BID ADDENDUM NO. 5

PROJECT NAME: PORT CHESTER HIGH SCHOOL ADDITIONS, ALTERATIONS
AND ATHLETIC FIELD

F&D PROJECT #: PCHS # 17295.03

DATE: February 28, 2019

DRAWING TITLE:
OVERALL SITE PLAN SCHEMATIC

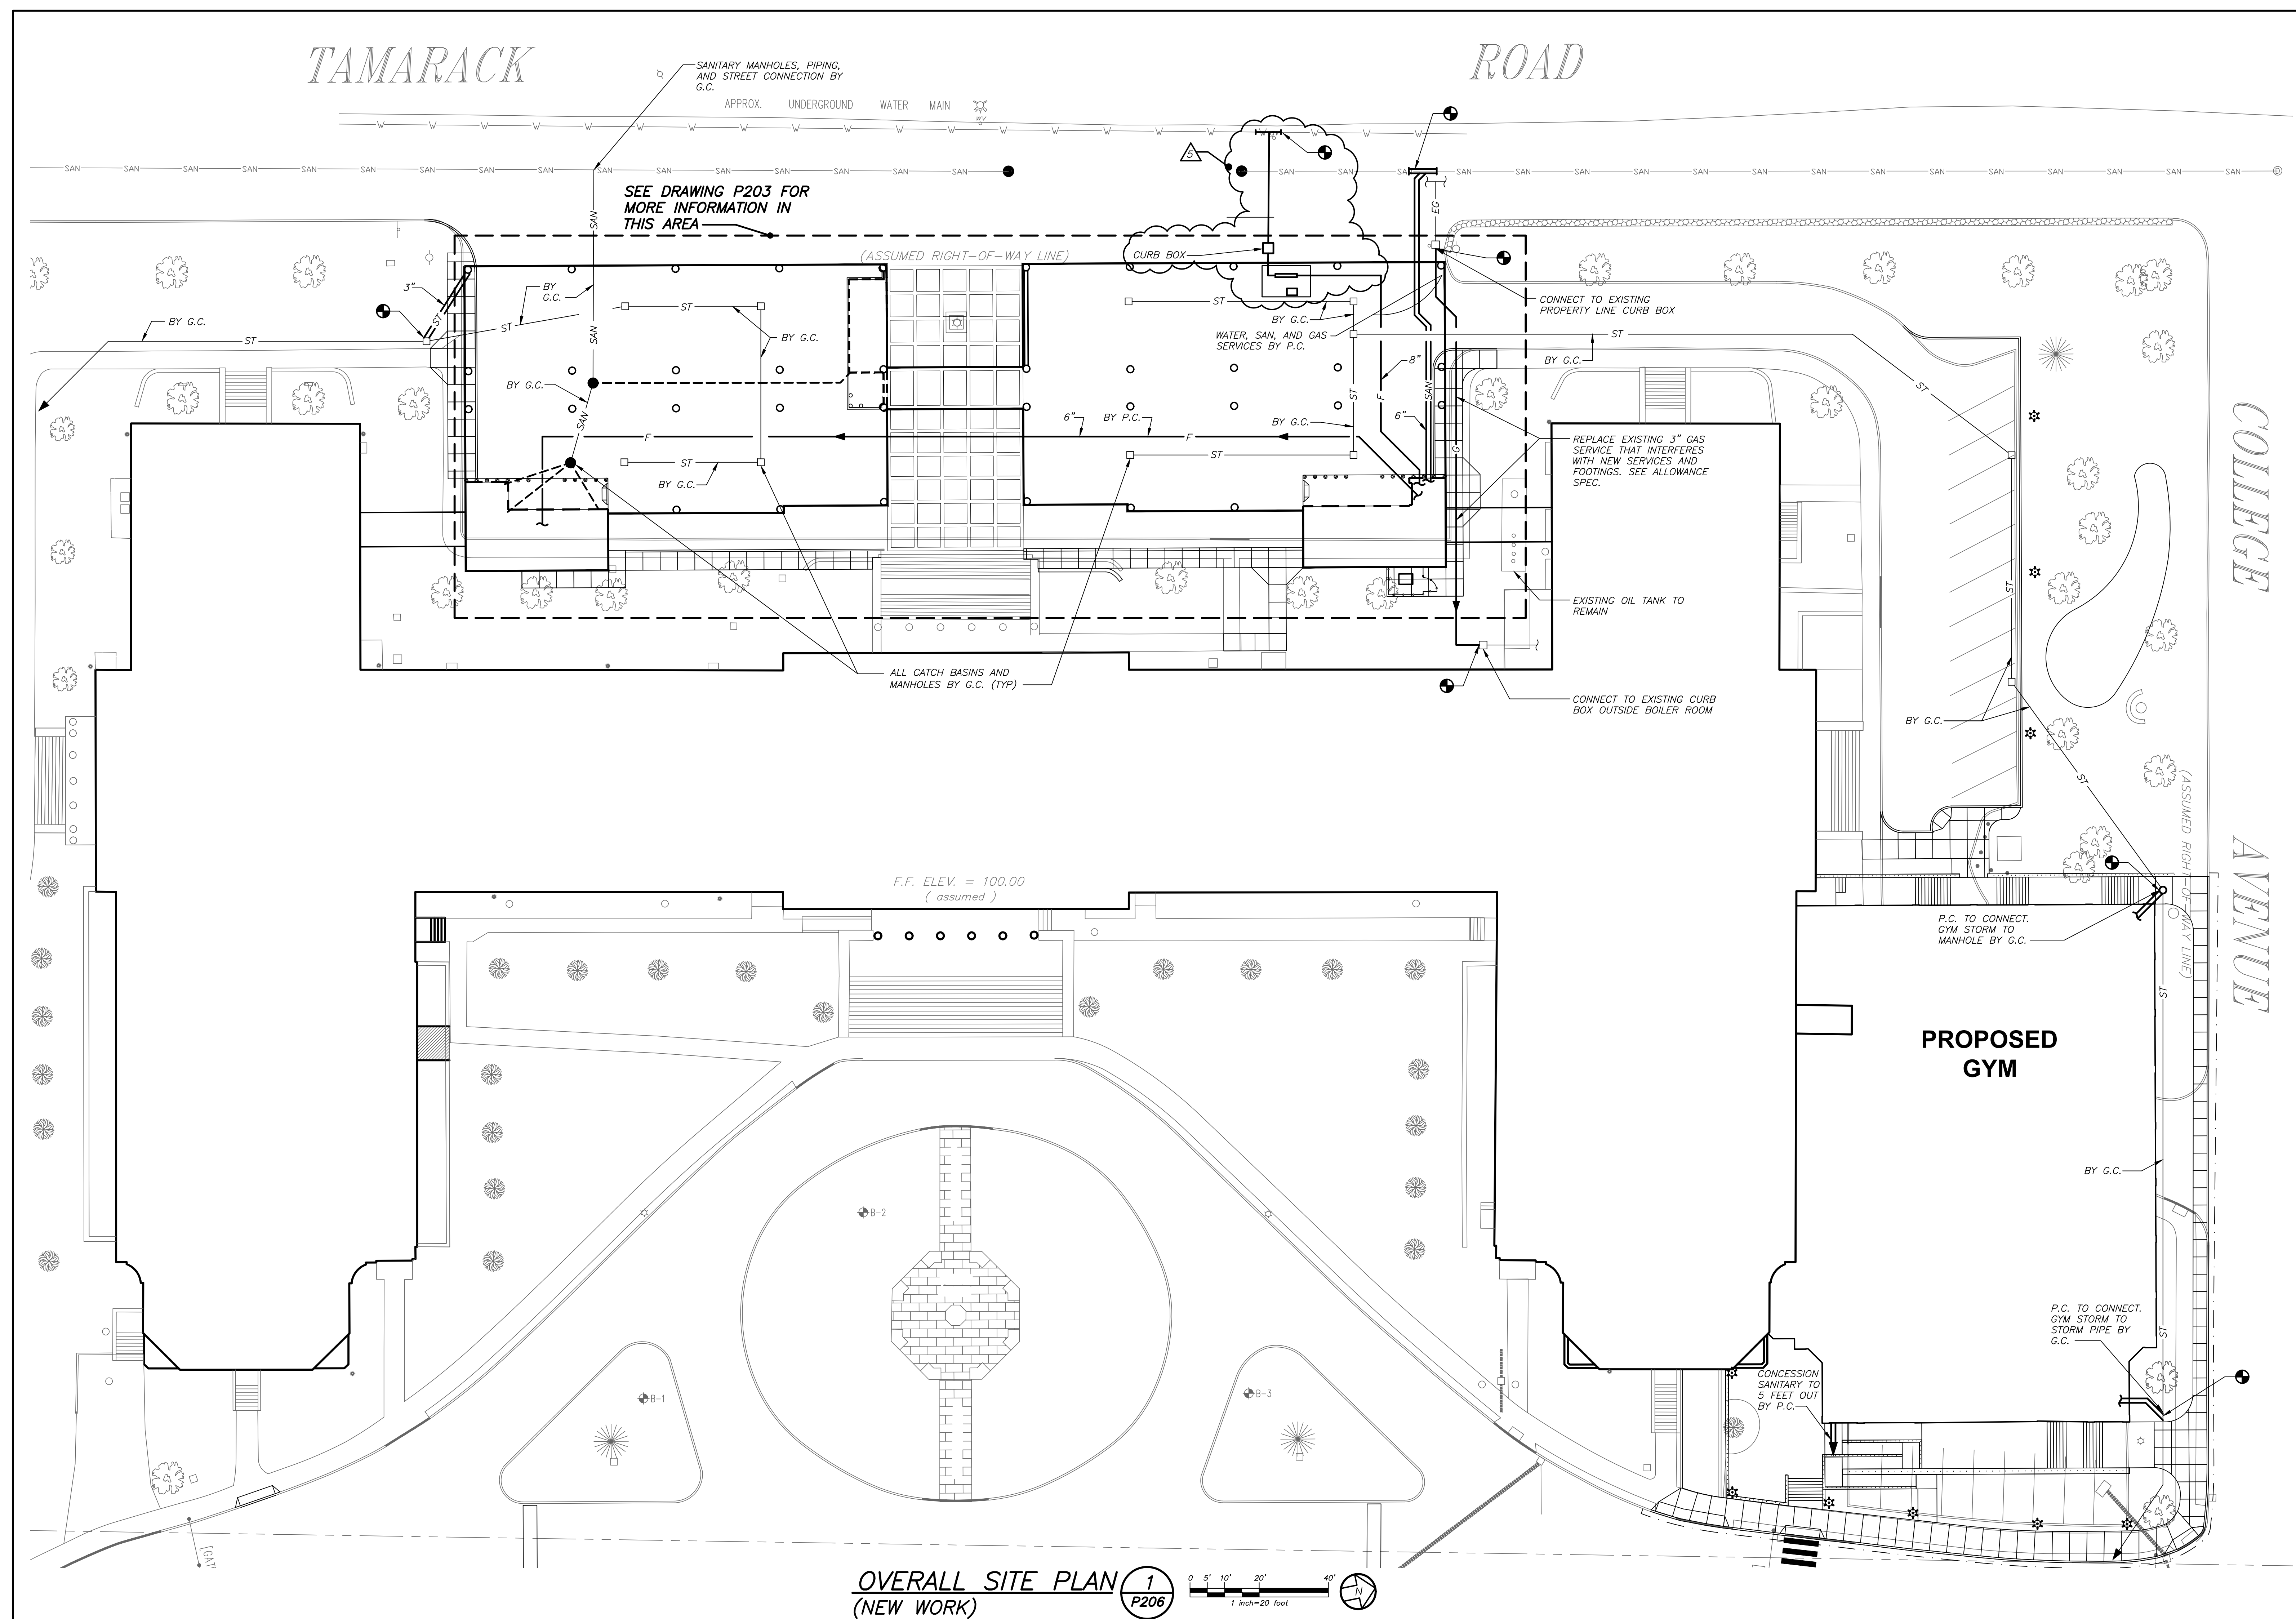
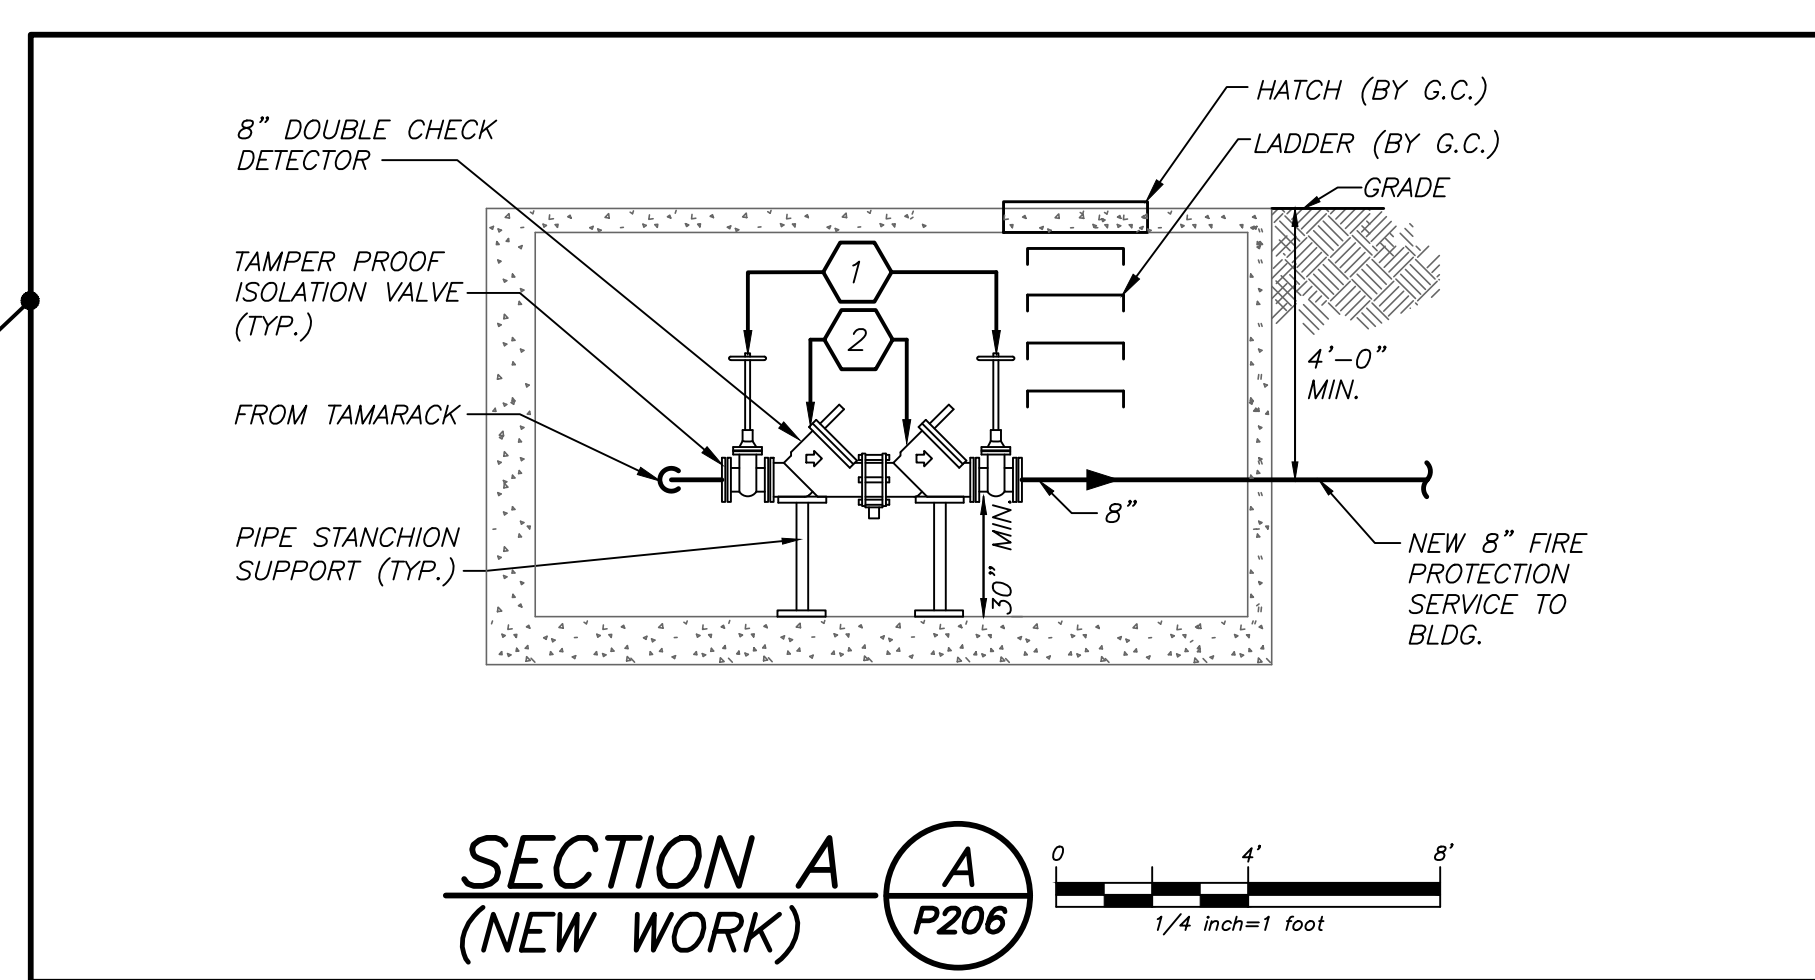
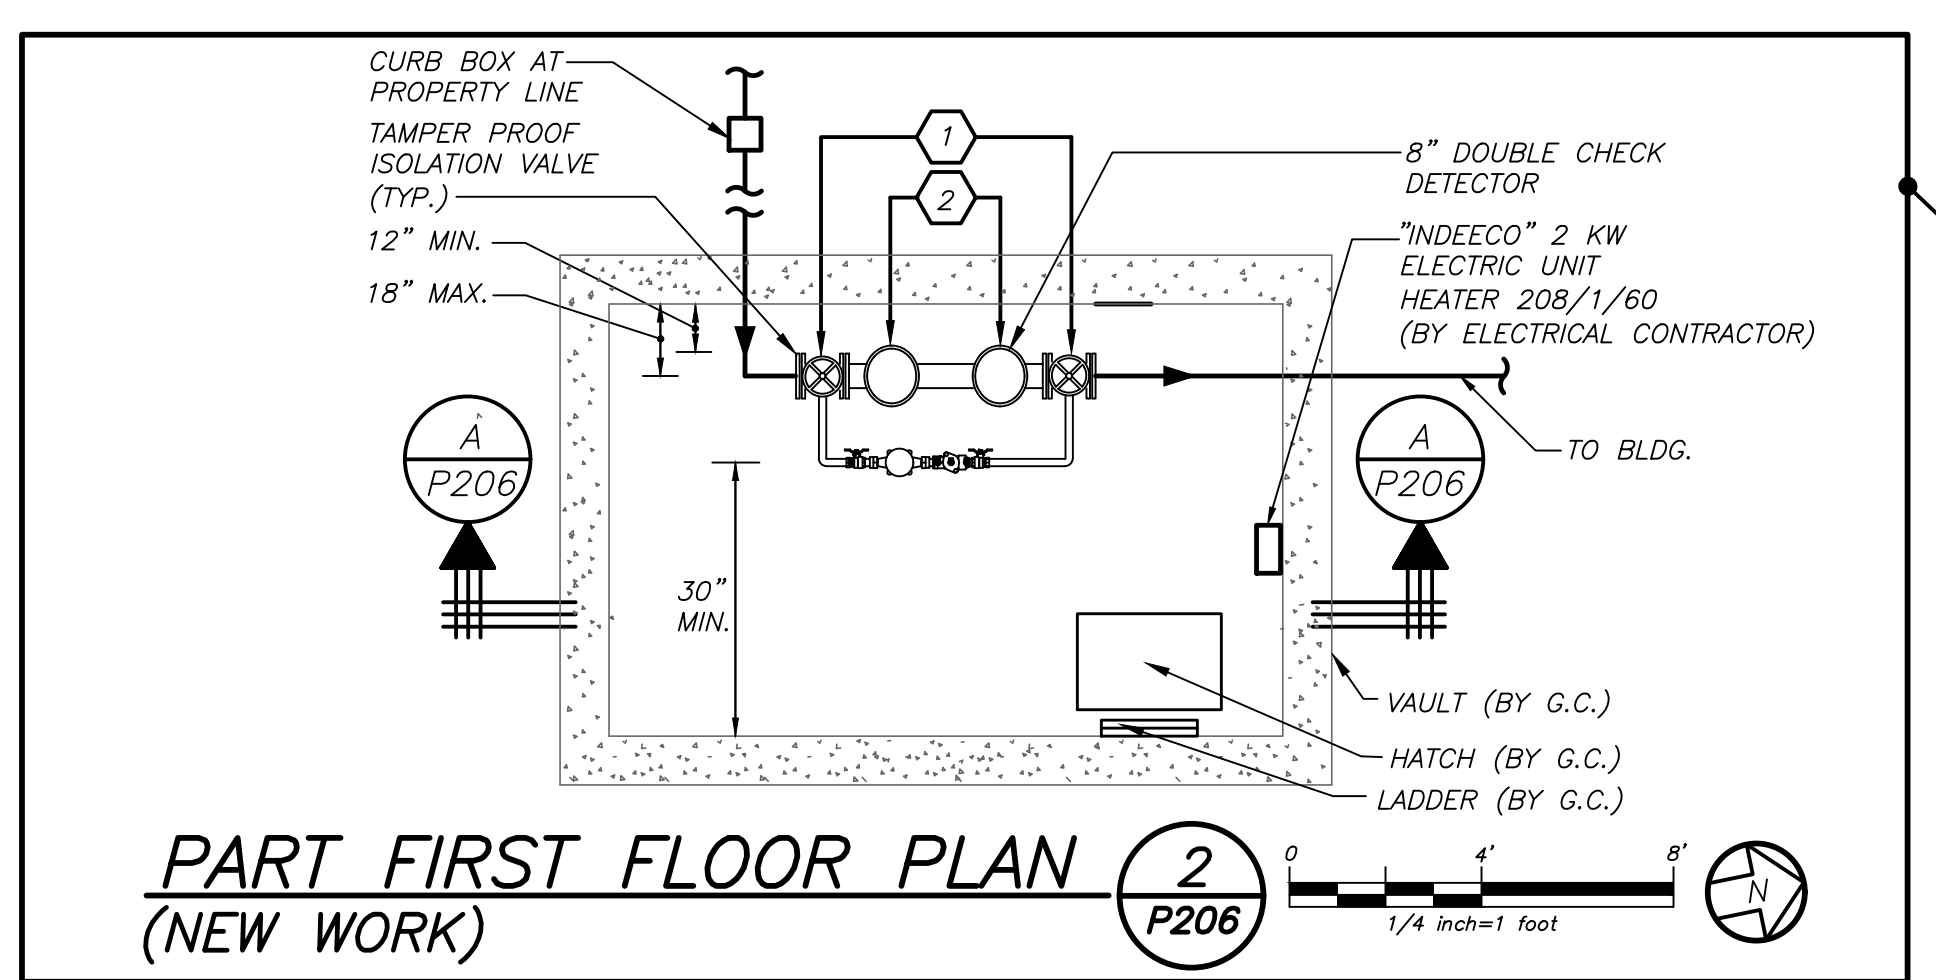
Add: A new 14'L x 8'W x 8'H precast concrete vault has been added to the project. See requirements listed below:

- Provide engineered prefabricated, reinforced precast concrete vault rated for H20 wheel load. Submit shop drawings signed and sealed by N.Y.S. P.E. As manufactured by Precast Concrete Solutions or approved equal.

- Provide membrane waterproofing over the entirety of the vault.
- Set vault on 12" compacted crushed stone.
- Detention tank shall be tested for leakage in the presence of the Engineer, and according to the standard test: HST-VIO. Test shall be performed after all of the structure is complete and concrete has attained its design compressive strength, and prior to backfilling. All tanks penetrations and outlets shall be securely sealed to prevent the loss of the water during the test. If the water is to be filled using the tank inlet pipe, positive means shall be provided to check that water is not entering or leaving the tank through this pipe. Tank penetrations and pipe outlets shall be monitored before and during the test to ensure the water tightness of these appurtenances. Leakage of these outlets shall be repaired prior to test measurements. The ground water level shall be brought to a level below the top of the slab and kept at that elevation during the test. The tank shall be filled with water at a rate not exceeding four (4) feet per hour. Filling shall be continued until the water surface is at the design maximum liquid level or four (4) inches below any fixed overflow level, whichever is lower. the exterior surfaces shall be inspected during the period of filling the tank. If any flow of water is observed from the tank exterior surfaces, including joints or cracks. The defect causing the leakage shall be repaired. The structure shall be inspected daily for damp spots, seepage, and leakage. There is no numerical value for the allowable loss of water during the HST-VIO tightness test. However, there shall no water observed flowing or seeping from the tank for 24 hours after the tank is filled to the test level.

- See revised P203 and P206 for exact location and additional information.
